**BLOOMINGTON BOARD OF ZONING APPEALS
STAFF REPORT
LOCATION: 4201 W. 3rd Street**

**CASE #: V-19-11
DATE: May 26, 2011**

PETITIONER: St. Paul United Methodist Church
4201 W. 3rd Street, Bloomington

REQUEST: The petitioner is requesting a package of variances including: maximum size for an accessory structure, setback standards, maximum parking, landscaping and maximum driveway width standards to allow construction of a 2,634 square foot accessory structure.

V-19-11
St. Paul United Methodist Church
Elevations of Garage

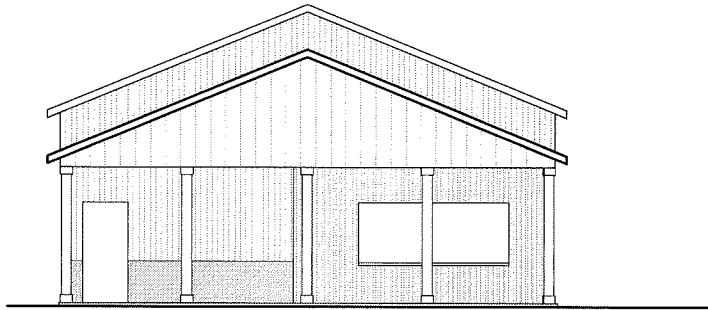
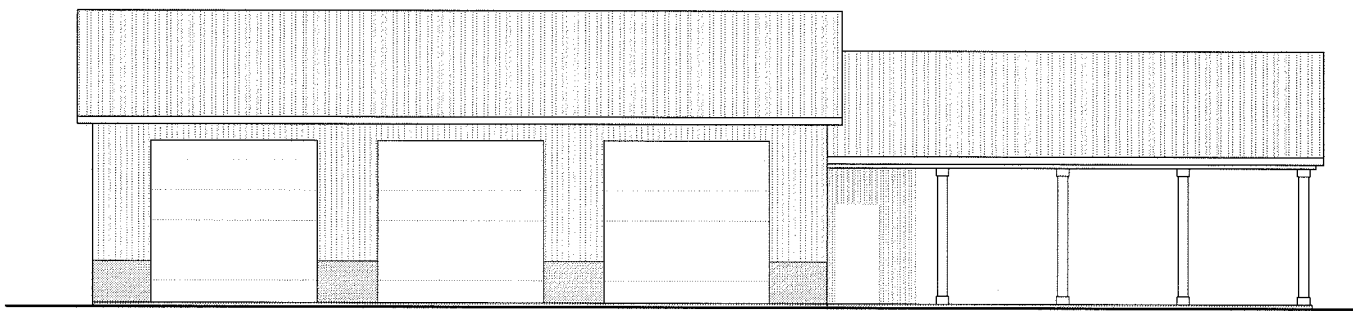
The proposed structure does not meet front garage setback standards and maximum accessory structure size standards. In addition, a proposed dumpster enclosure also does not meet setback standards for dumpsters.

Accessory structure size: The UDO allows for a maximum accessory structure size in the CG district of 1,500 square feet. The proposed 2,634 square foot accessory structure exceeds this maximum. The fully enclosed portion of the structure only exceeds the maximum by 89 square feet. The petitioner contends that the larger accessory structure is

needed to house maintenance equipment and a church bus, that the large size of the structure is mitigated by the larger combined lot size (nearly 7 acres) and that the impacts of the structure are reduced because 40% of the structure is an open sized picnic shelter. Staff concurs with these arguments.

RECOMMENDATION: Based on the written findings, staff recommends approval of all variances except for the maximum driveway width variance, with the following conditions:

V-19-11
 St. Paul United Methodist Church
 Staff proposed changes to driveway

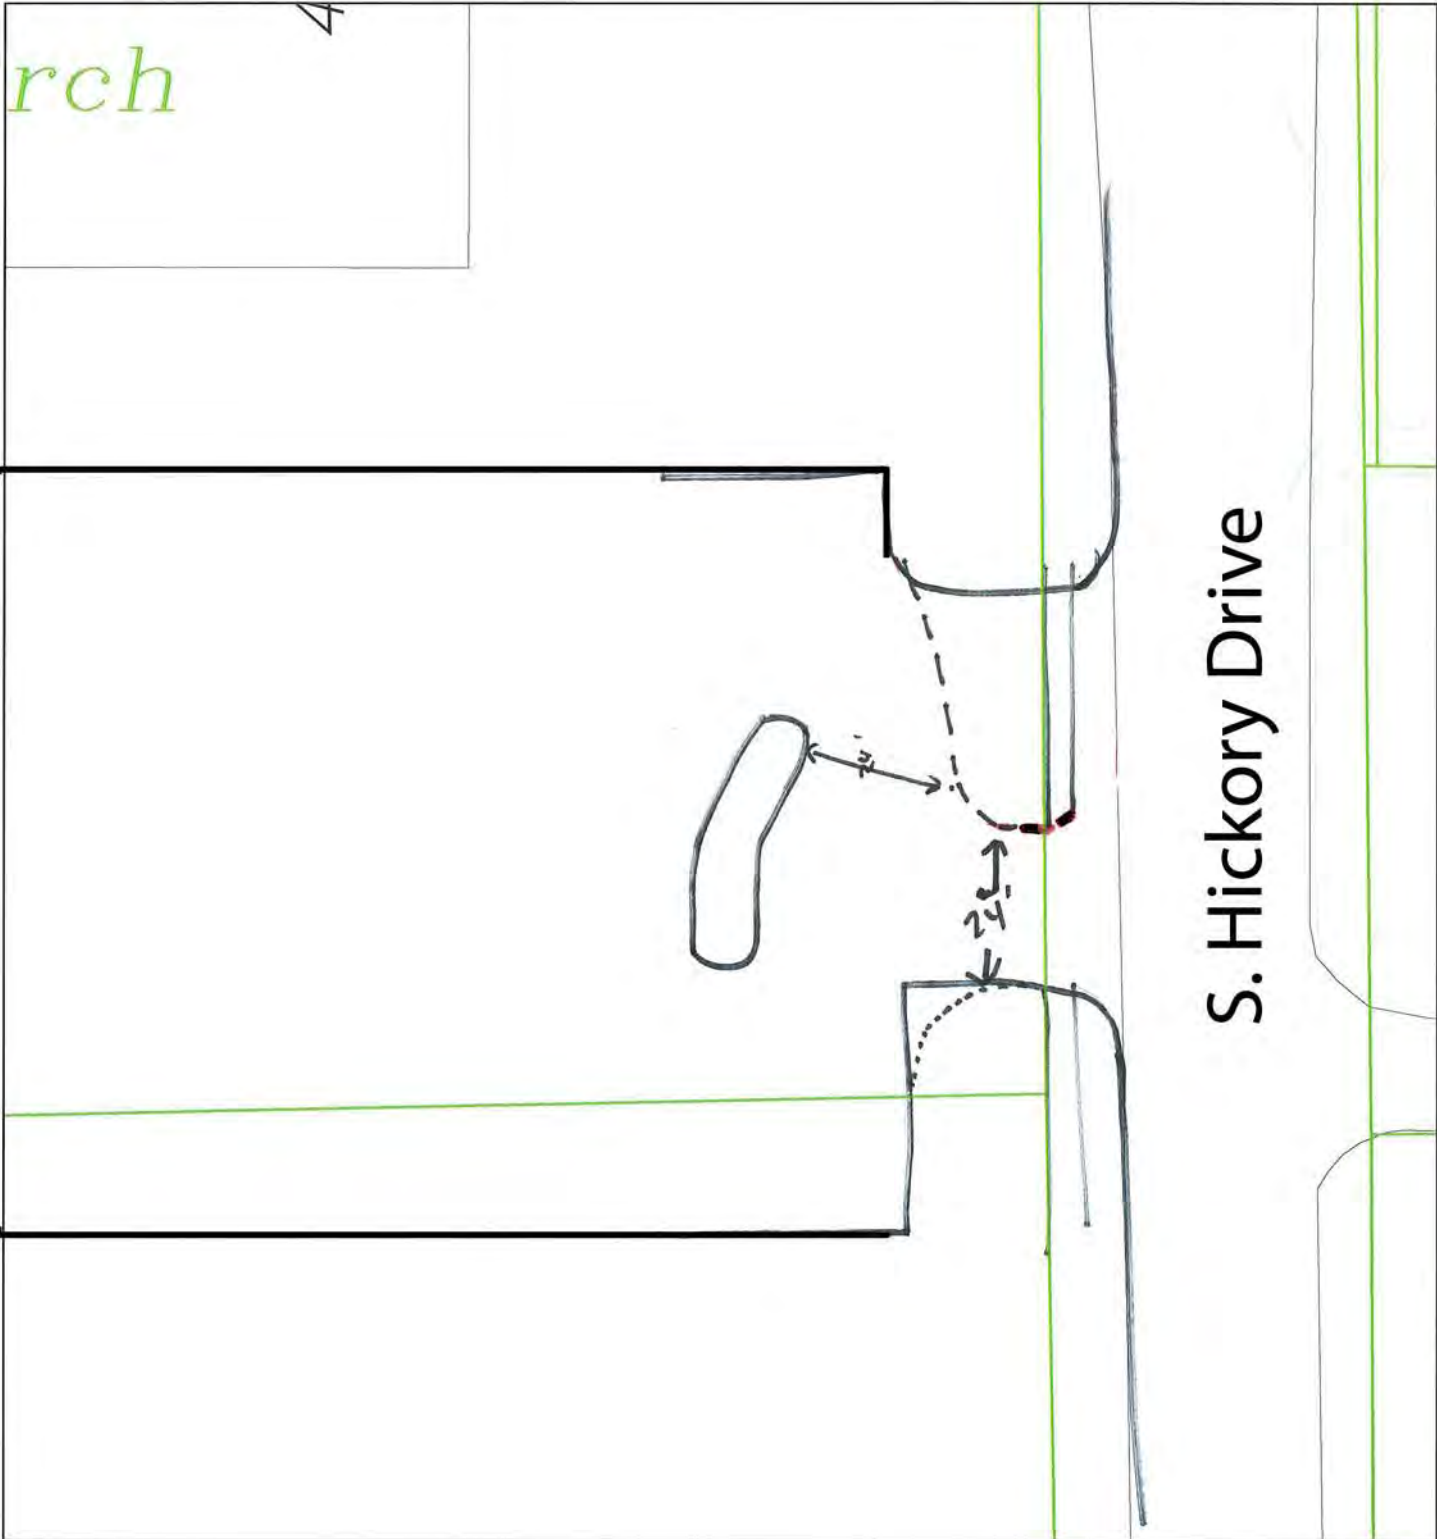
Driveway width: The current driveway onto Hickory Dr. is 60 feet wide. The petitioner received a grading permit in 2005 to allow for a parking lot expansion. That grading permit showed the site being brought into compliance with the code at the time. The driveway was shown reduced from 60 feet to under 40 feet, which was the maximum at that time. This driveway width reduction never took place. Since 2005, the UDO further reduced the maximum driveway width onto a neighborhood street from 40 feet to 24 feet.

The petitioner is requesting a variance to allow the driveway to stay at 60 feet. They contend that driveway compliance is too costly and that the extra width is necessary to allow for turning movements for their church bus, limousines for funerals and garbage trucks. Staff has analyzed the driveway with the City Engineer and found that by angling the approach to the drive or creating wide radii on corners, all turning movements can be accommodated. Staff recommends denial of this variance.

The PowerPoint shows what our entrance would look like if we have to reduce it to the 24 foot width. As you can see, it will take away over half of what we currently have.

We were more concerned with the entrance of the parking lot with our church bus, and other large vehicles, than we were with the exiting. The pictures show how tight it will be. As a matter of fact, I drove the bus into the parking lot and I was not able to turn the bus to get around the curb. I had to back the bus up and then turn hard to get around the curb.

I hope the pictures will help to show that reducing the entrance to 24 feet will not work. The curb at the entrance is what makes this impossible. As a reminder, the curb and landscaping were placed in that location, as required by the city when we did the parking lot project. We asked about not putting the curb there, but were told we had to.

Staff's Finding: Staff finds no peculiar conditions. A 24 foot wide driveway is a standard commercial driveway. The entrance can be designed to provide adequate turning radii for large trucks. Staff finds no practical difficulty. The reduction in the driveway width is an unfulfilled site compliance issue from 2005.

1. Approved variances for landscaping, lighting and maximum parking are only associated with the currently proposed structure. Future building additions or expansion of use on the property shall require compliance with all UDO standards.
2. The driveway on Hickory Dr. shall be reduced to 24 feet in width prior to final occupancy of the structure.
3. A pedestrian easement shall be recorded for the portion of the Hickory Dr. sidewalk that is not located within the right-of-way, prior to final occupancy of the structure.
4. Eight (8) class-II bicycle parking spaces are required in the location indicated on the site plan prior to final occupancy of the structure.
5. Required five (5) foot wide sidewalks shall be constructed and inspected prior to final occupancy of the structure. A ROW excavation permit is required for the sidewalks.

Thank you for your extra time and drawing that you sent. It is clear that you are trying to help us as much as possible. I did look at your drawings and believe it would be easier to make that turn as you have drawn. Certainly, no backing up of our bus, or Head Start's bus would be needed.

V-19-11
 St. Paul United Methodist Church
 Garage and dumpster setback
 2010 Aerial Photo

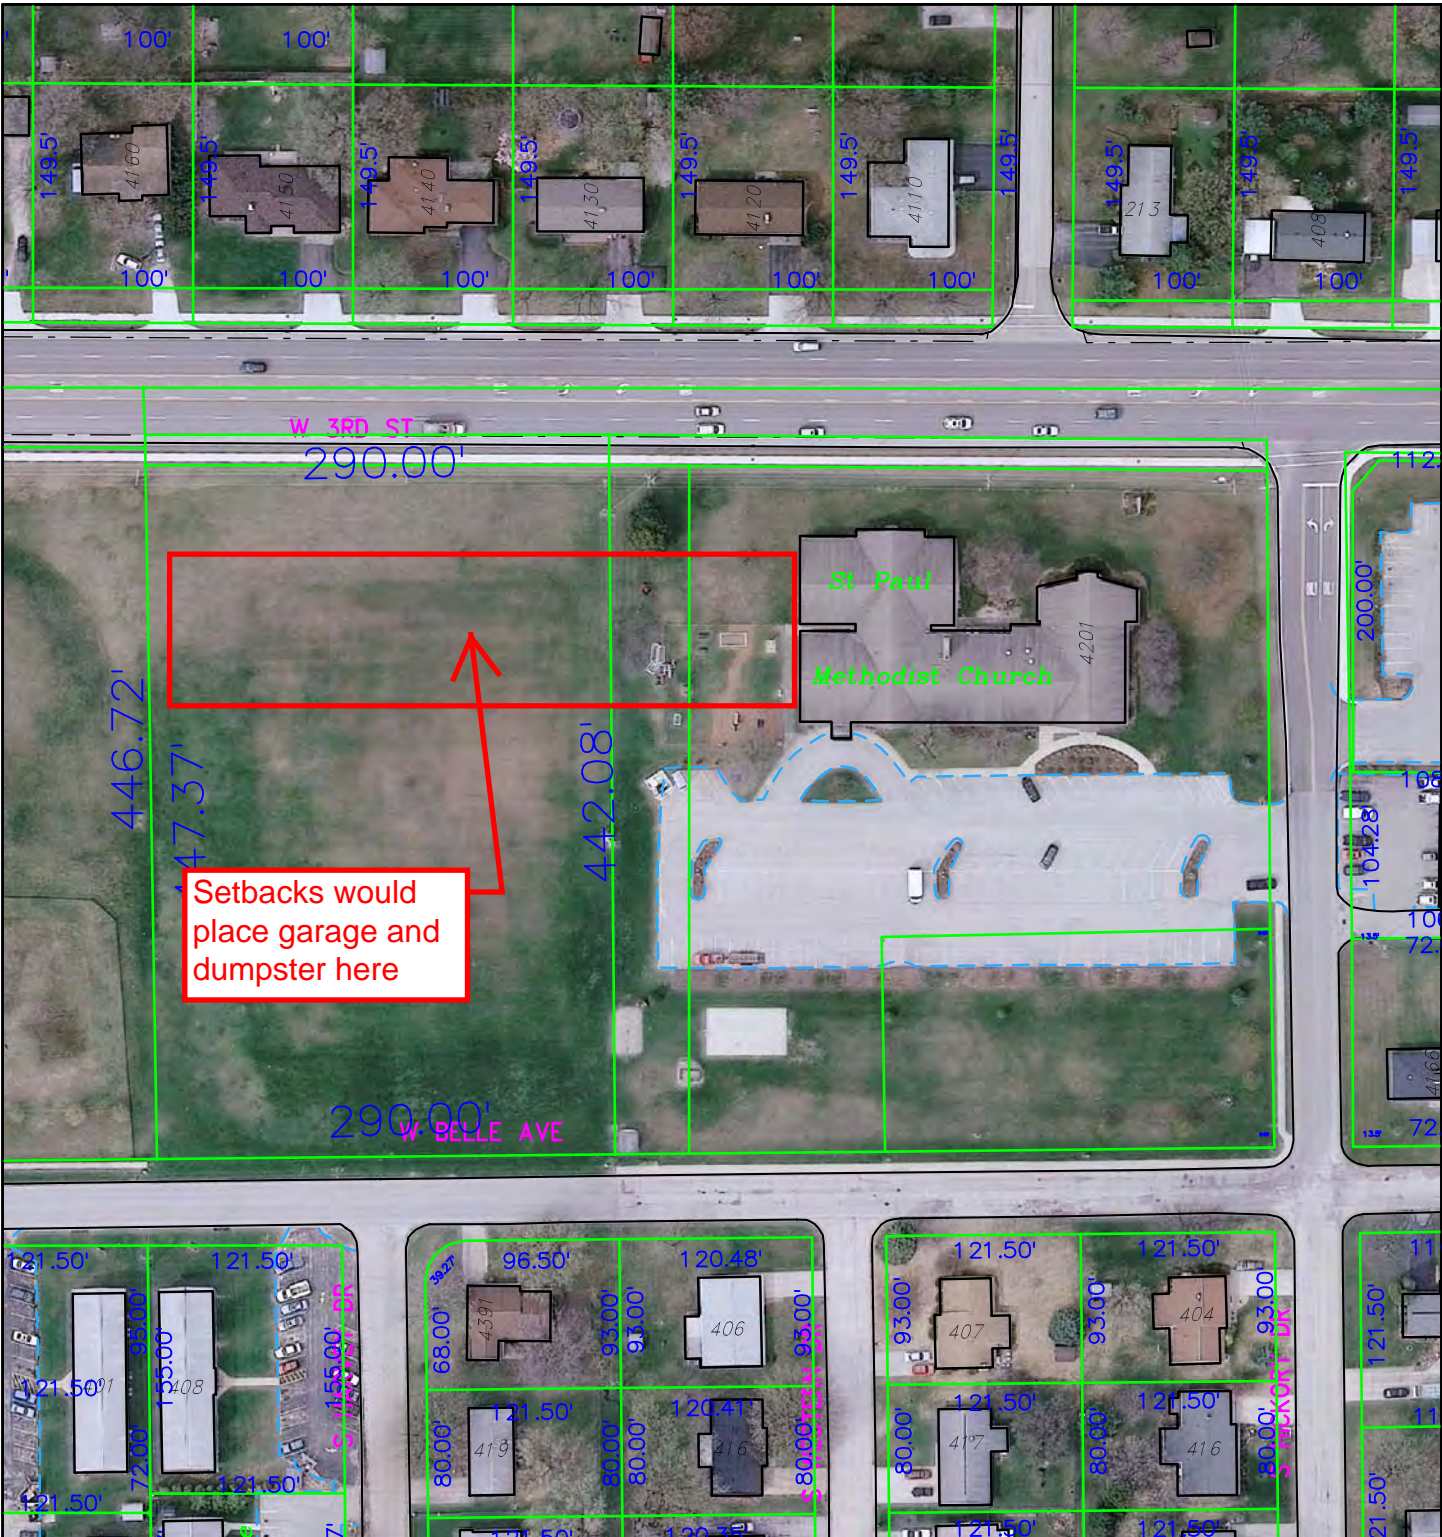
Setbacks: The UDO requires that garages be located at least 10 feet further back from the street than the main structure. The UDO also states that dumpsters are prohibited within the front setback. Because this property is surrounded on three sides by streets there is only a narrow area on the west side of the church where these features can be located. A drawing is included in the packet.

Staff's Finding: Peculiar condition for the setback variance can be found in the fact that the property is surrounded on three sides by streets, thus creating a very small area where the setbacks can be met. Peculiar condition for the maximum accessory structure size is found in the large lot size (6.9 acres), the relatively small size of the structure (only 13% of the size of the church.) Peculiar condition for the parking maximum variance is found in the large size of the lot and the surrounding streets. The building and parking cover only 24% of the property with impervious surfaces. If the parking lot met setbacks, which would be difficult to do considering the three streets, compliance would not be required with the maximum parking standards. Peculiar condition for the lighting and landscaping variances is found in the proportionally large size of the property in relation to the smaller building.
